CHANGE/ERRATA INFORMATION

ISSUE NO: 3

Title: 8020A DIGITAL MULTIMETER
Print Date: April 1979
Rev. and Date: -----

Figure 1.

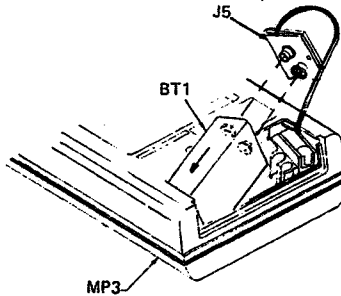
On page 1-4, replace Figure 1-2 with Figure 1.

Figure 2.

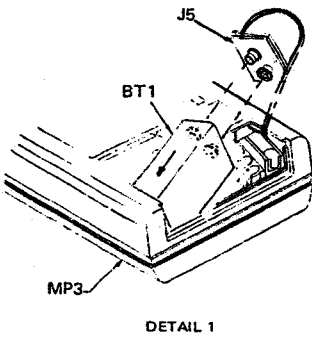
On page 5-5, replace figure 5-1 with Figure 2.

SEE DETAIL 1
FOR INSTALLATION
OF BATTERY

Figure 3.

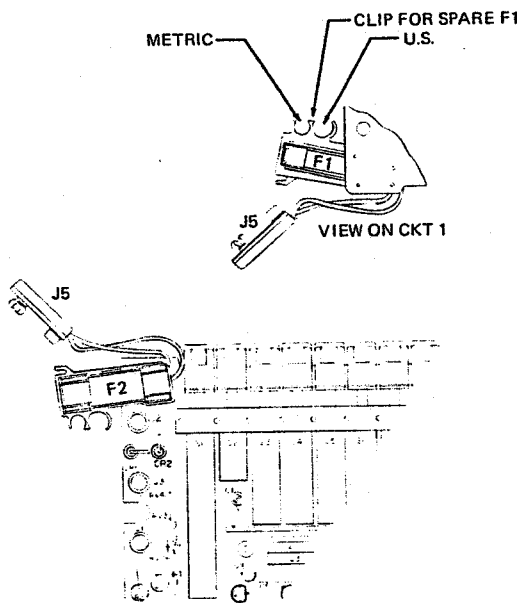
On page 5-9, revise figure 5-2 as shown in Figure 3.
